SPECIAL VILLAGE BOARD MEETING

1. Call to Order and Roll Call
2. Concept Plan – Sysco Corporation – W223 N16501 Cedar Parkway (1 Sysco Drive) – Discussion Only
3. Pre-Development Reimbursement Agreement – Sysco Corporation
4. Adjourn

STAFF REVIEW COMMENTS
SPECIAL Plan Commission Meeting – November 18, 2021

Agenda Item #2 – Concept Plan – Sysco Corporation– W223 N16501 Cedar Parkway (1 Sysco Drive)

NORTH TRUCK ENTRANCE SIGHT DISTANCE EXHIBIT

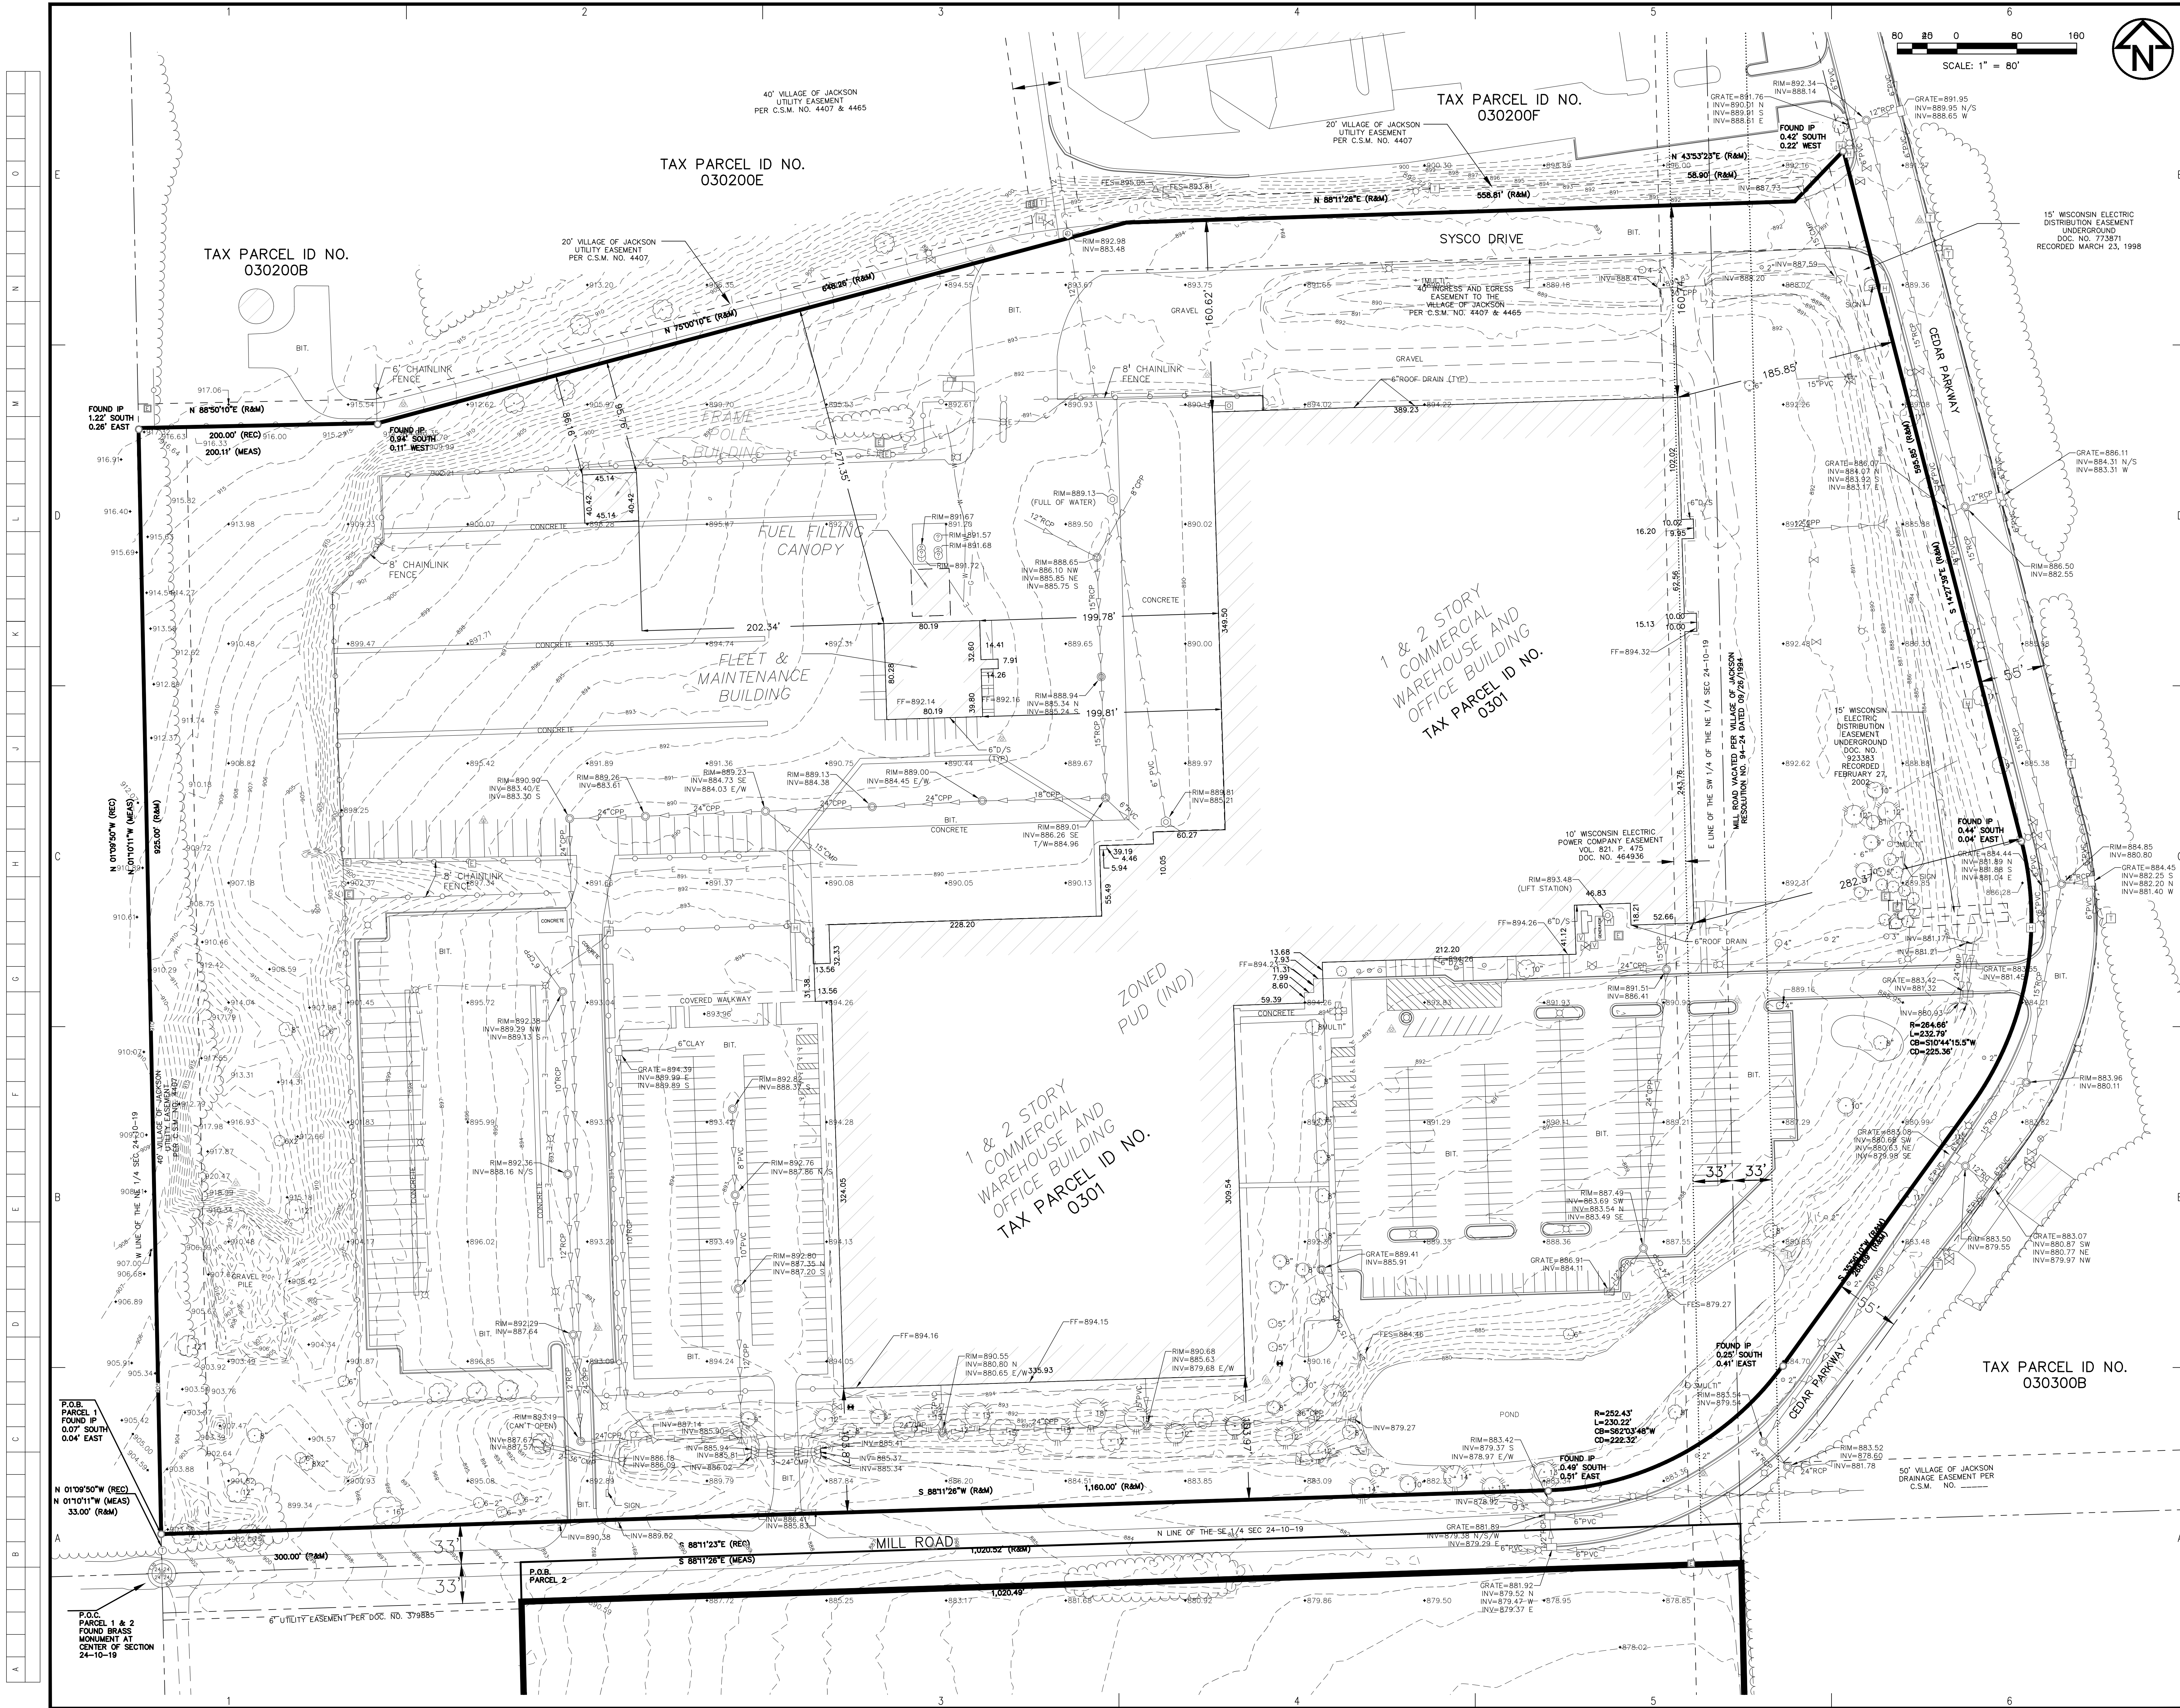
- My first concern is closing off Cedar parkway. From an emergency standpoint, this is not in the best interest of anyone. The area west of Sysco will be a big development in the future and this will obstruct emergency vehicles from rapidly accessing these locations. My only alternative solution to this is to extend the road around the projected area at Sysco's cost. This is not ideal but is a compromise.
- As far as the addition, I see no objections as long as a comprehensive plan is put in for the additional ammonia system.
- State approved plans for the sprinkler system and fire alarm will be required.

NORTH SITE PLAN

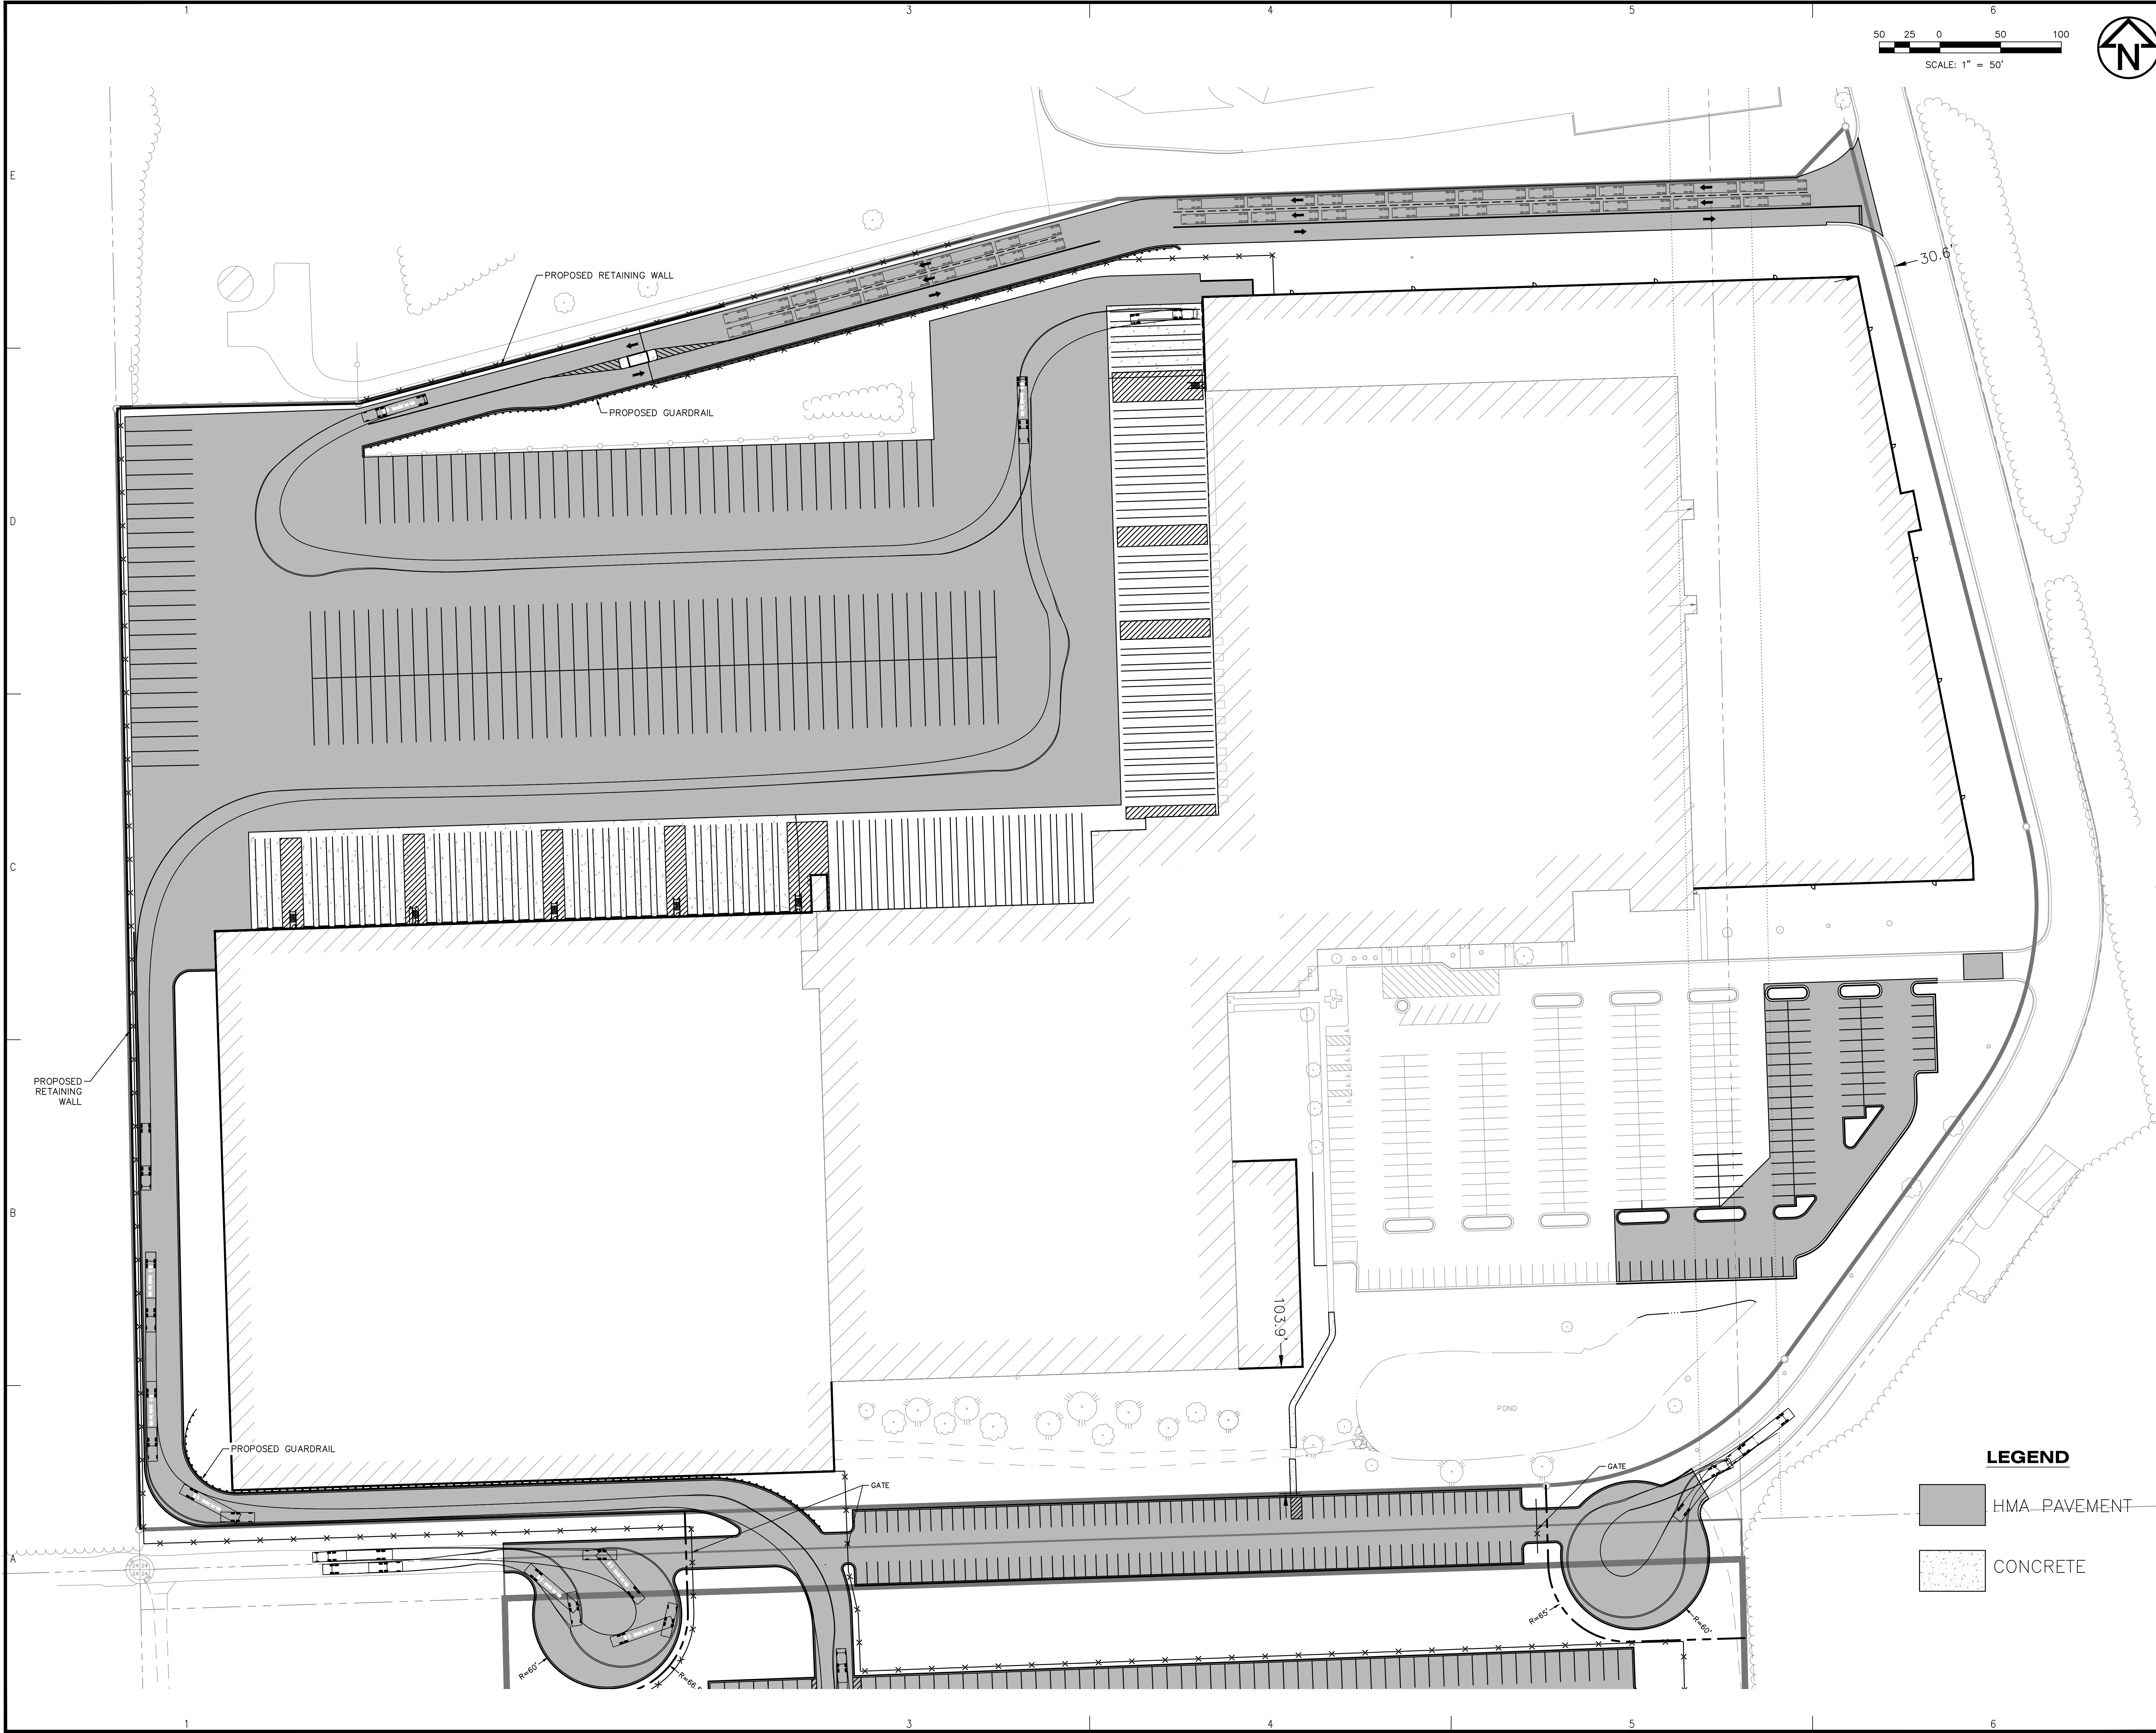
- The submitted plans do not show any form of buffering between the south truck lot and the adjacent residential properties. Buffering is typically required by ordinance.

- It appears, based on the submitted plans, that the parking lot and roadways planned along the west property line will in fact extend to the property line leaving little if any buffer. A retaining wall is planned for the entire length of the west property line. The details of this retaining wall, parking lot, and roadway are not known at this time however, appropriate setbacks are required as well as potential buffers.

- Proposed lighting for south truck parking lot, and how the lights will affect the adjoining properties.
- Is the south truck parking area only used for storage or are the trucks/trailers running 24/7/365-time frame?
- The proposed plan does not have a buffer for the existing single-family residence. Create a buffer by landscaping and berm or move the parking lot to the west side of the property and place the pond on the east side of property providing the buffer.

ELEVATIONS

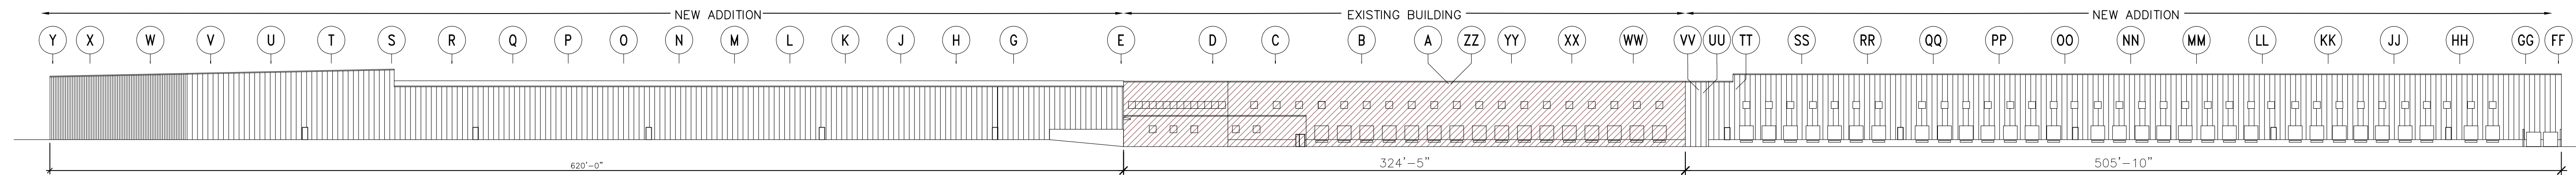
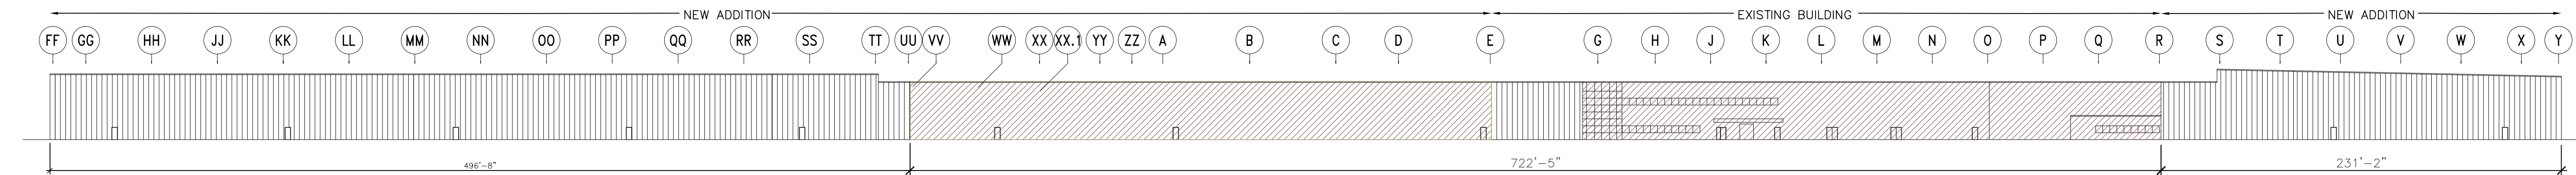
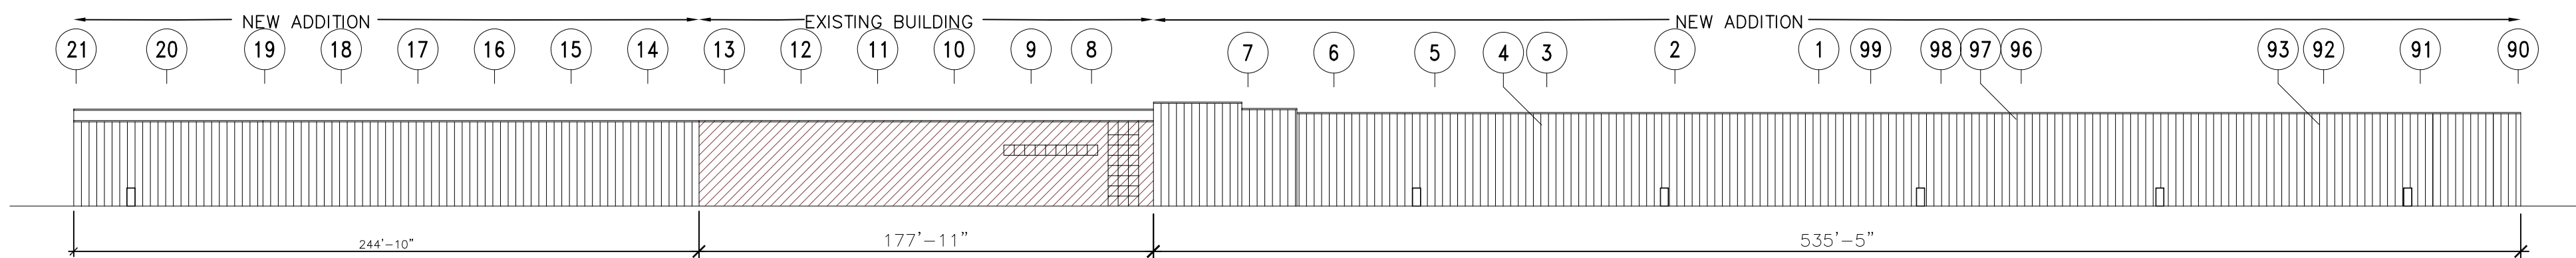
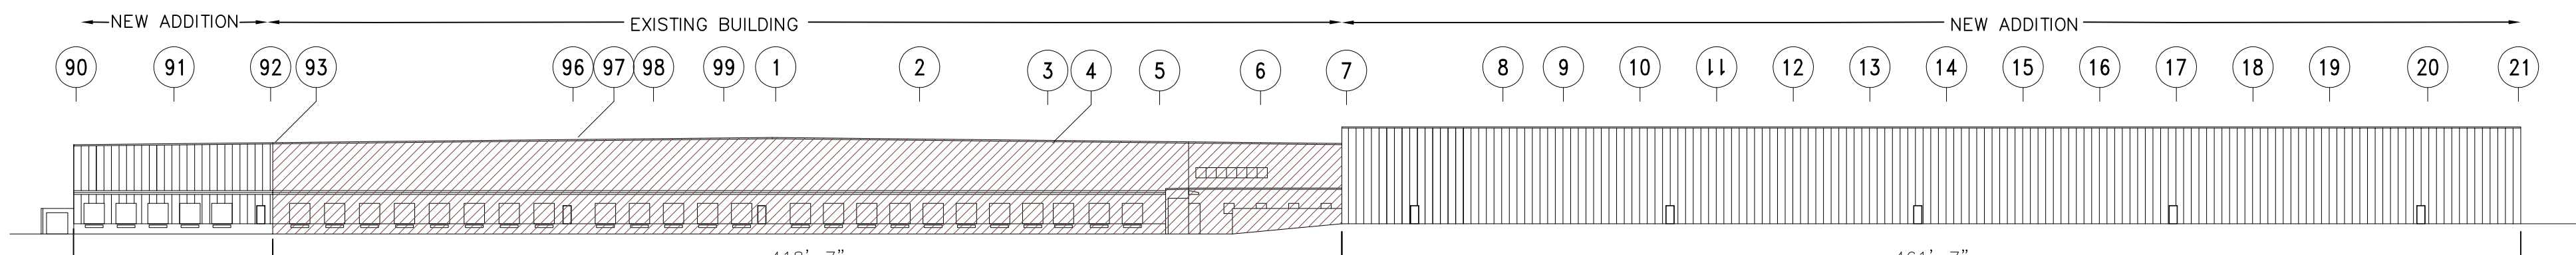
- Existing building height is 33-feet, proposed east and north façades are 39-feet in height along the west side of Cedar Parkway.
- An existing ingress/egress easement is shown along the east property line of the proposed annexed property. It is assumed this is intended to provide access to both the residential lot located adjacent to the northeast corner of the annexed property and the undeveloped parcel located along the southeast corner of the annexed property.

- If the proposed building is allowed to encroach up to the east property line, it is recommended that the building incorporate aesthetic elements that “breakup” large white wall which would be just over 958- feet in total length. Significant landscaping elements should also be incorporated to provide additional “buffering”.
